APPLICATION NO.	FILING DATE	FIRST NAMED INVENTOR	ATTORNEY DOCKET NO.	CONFIRMATION NO.
10/612,918	07/07/2003	Kelly F. Williams	91429MGB	6941

Office Action Summary

DETAILED ACTION

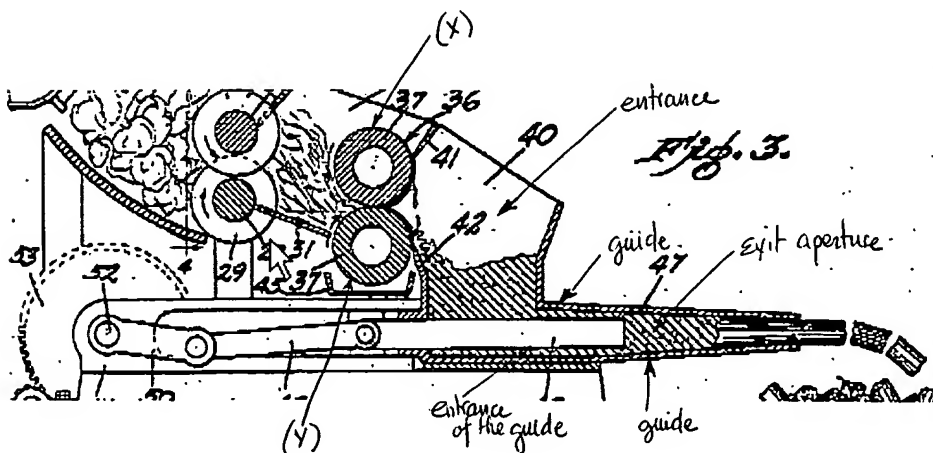
Regarding claim 1, Paxton discloses a compactor comprising: an elongate compression chamber having an entrance and an exit aperture (see the illustration below); a pair of opposing input rollers (37) located at the entrance to the pre-compression chamber, at least one of the rollers provided with rotational drive (page 2, lines 12-14); a moveable plunger (48) operable to sweep a volume of the pre-compression chamber between the entrance and the exit. As to the added limitation “a slipsheet” in the claim, since the invention is related to the compactor, and no patentable weight is given to the material that is used in the apparatus. Therefore, Paxton discloses the compactor as claimed as set forth above, thus the compactor is capable of compacting slipsheet.

Regarding claim 2, the pre-compression chamber has a transverse cross section that is inwardly tapered towards the exit aperture (see the illustration above).

Regarding claim 3, the pre-compression chamber comprises a pair of spaced apart guides defining a passageway having an entrance at one end thereof and defining the exit aperture at the other end thereof, the passageway inwardly tapered at least in a portion in proximity to the exit aperture (see illustration above).

Regarding claim 21, a first one of the input rollers (see (X) in the illustration above) has an arc length exposed in the pre-compression chamber longer than an exposed arc length of a second one (see (Y) in the illustration above) of the input rollers.
